Petition Number: 2023-172 General Location Identifier: 03113241

| Revision Log: | Date | Description | | |

General Review Information

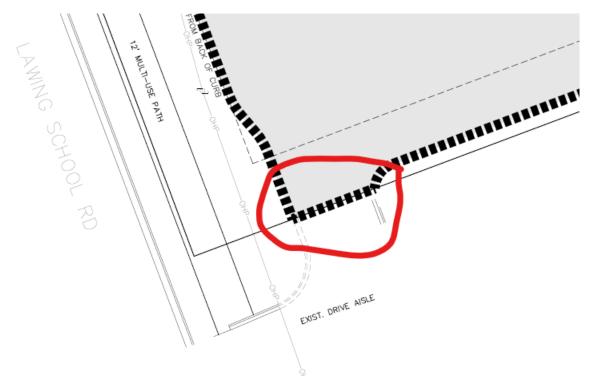
The petition's zoning falls within the low intensity development which based on the 1,149 daily trips will trigger Tier 1 (3 mitigation points) for multimodal assessment. The petitioner shall review and assess the publicly accessible pedestrian network within 1/4 mile walking distance of the site to identify multimodal infrastructure to meet the Tier 1 (3 mitigation points) for multimodal assessment.

Clarifying Comment/Response 02-21-24: Previous rezoning of the site is not applicable to the current proposed rezoning and requirements under the City of Charlotte UDO. Petition will be required to complete a traffic study and other CTR requirements.

Comment Resolved 03-25-24: Density has been reduced.
